LAKE PONTCHARTRAIN, LOUISIANA AND VICINITY
DESIGN MEMORANDUM NO. 1
HYDROLOGY AND HYDRAULIC ANALYSIS

PART III - LAKESHORE

1. Pursuant to para 17a, ER 1110-2-1150, the subject design memorandum is forwarded for your review and approval. Approval is recommended, subject to the following comments.

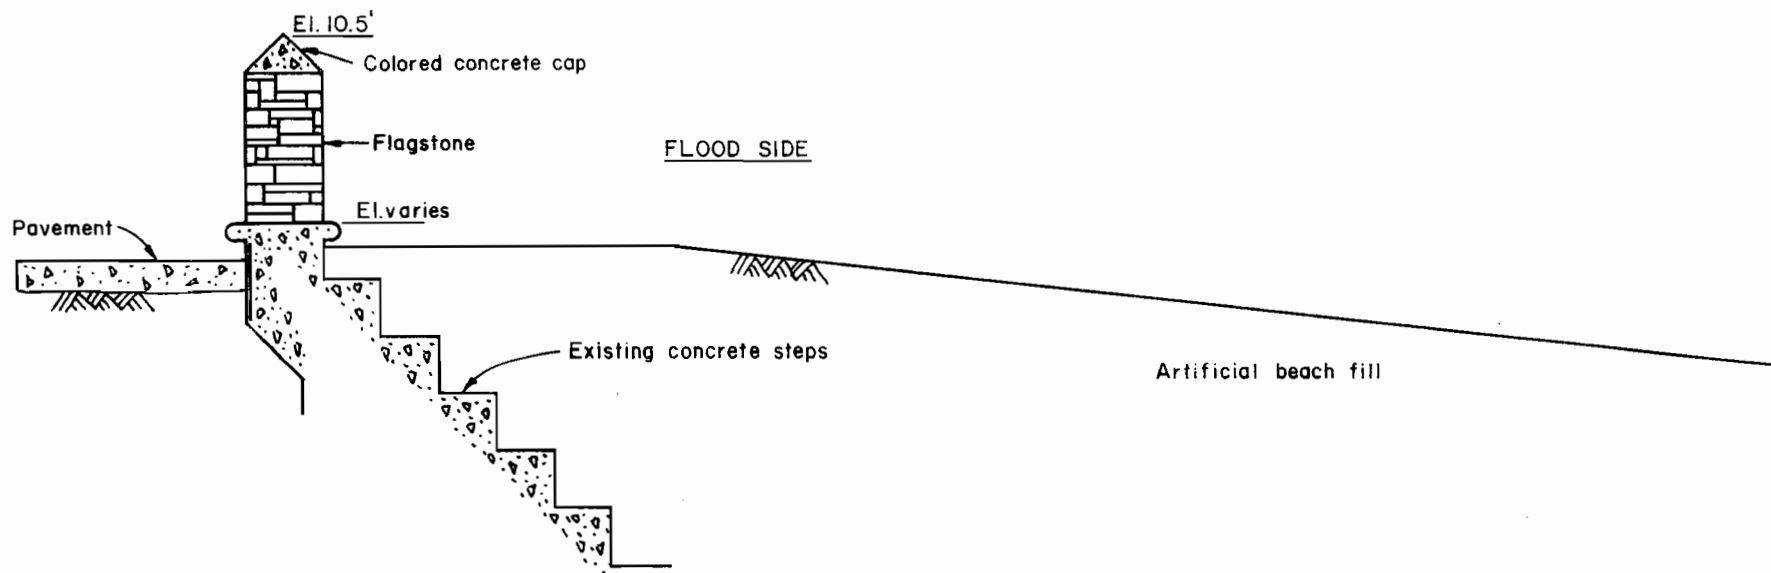
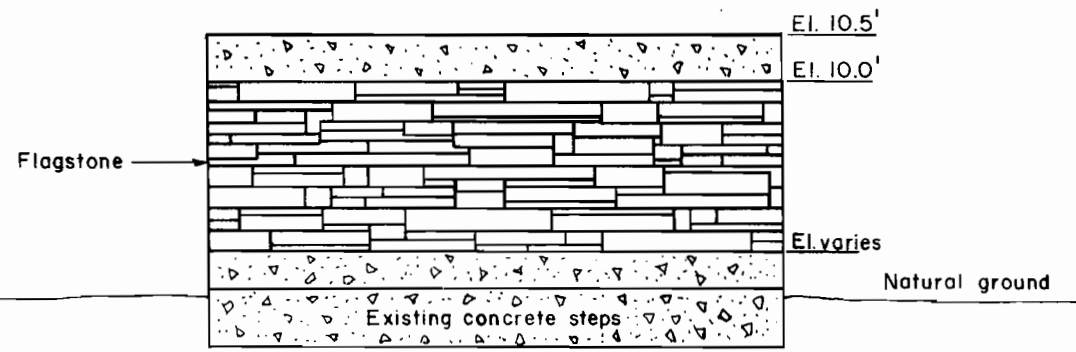
7. Plate 8, a. The fact that the flagstone wall is an existing wall should be indicated.

b. Since the flagstone may be structurally inadequate, the DM should indicate that this wall is not necessarily the protective structure and that only its general shape was used to determine wave runup.

f. Ref. par. 7a. This comment is concurred in.

g. Ref. par. 7b. The flagstone wall shown on plate 8 illustrates the general shape which was used to determine wave runup. Structural strength will be achieved with an inner core of properly reinforced concrete which will be faced with flagstone for beautification.
